UNITED STATES PATENT AND TRADEMARK OFFICE

10/667,144

Office Action Summary	Application No. 10/667,144	Applicant(s) CARLEY ET AL.	
	Examiner LINDSEY BACHMAN	Art Unit 3734

DETAILED ACTION

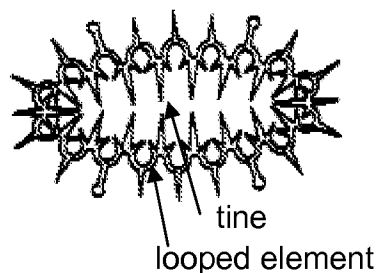
Claim 17: Spence'692 discloses a clip having a ring-shaped body (MR) defining a plane and disposed about a central axis (intersection of lines B-B and MLA in Figure 7), the body (MR) is capable of being moved from a substantially planar configuration to a transverse configuration because it is malleable (column 8, lines 16-23). Further, the body (MR) contains a plurality of loop elements (see alternate embodiment in Figure 9b) and a plurality of tines (see labeled copy of Figure 9b below) extending from the looped elements towards the central axis. Further, Spence'692 teaches spring elements (MD) that can be used to shape the clip (column 8, lines 25-30).

Spence'692 does not teach a biased spring element that limits the penetration depth of the adjacent tines.

Peterson'303 teaches a device for engaging tissue that contains a device with tines (16) with biased spring elements (18) between adjacent tines that resiliently allow the tips of the tines to be moved away from one another and also limit the penetration

depth of the tines (see Figure 2, 3, and 10-14, for example, but other configurations disclosed by Peterson'303 may also show this). This spring element extends in the same direction as the tines. It would have been obvious to one of ordinary skill in the art at the time the invention was made to rearrange the device taught by Spence'692 with the biased spring elements extending in the same direction as the tines, as taught by Peterson'303, since it has been held that rearranging parts of an invention involves only routine skill in the art. *In re Japikse*, 86 USPQ 70.

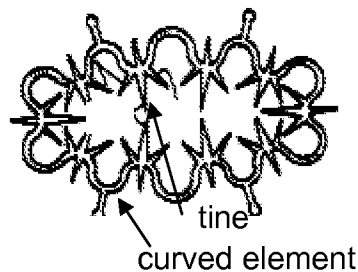
Regarding Claim 19, Spence'692 discloses the looped elements (see Figure above) is a series of outer curved regions connected to one another and the tines (see Figure above) extend from the connection regions of the adjacent curved regions.

Regarding Claims 36, Spence'692 discloses a clip having a ring-shaped body (MR) defining a plane and disposed about a central axis (intersection of lines B-B and MLA in Figure 7), the body (MR) is capable of being moved from a planar configuration to a transverse configuration because it is malleable (column 8, lines 16-23). Further, the body (MR) contains a plurality of curved elements (see alternate embodiment in Figure 9c) and a plurality of arcuate tines (see labeled copy of Figure 9c below and arcuate features in element TB in Figure 8a) extending from the looped elements towards the central axis. Further, as shown in Figure 8a, the tines are arcuate at the point that the tine extends from the ring. Further, Spence'692 teaches spring elements (MD) that can be used to resiliently move the tops of the tines away from each other (column 8, lines 25-30).
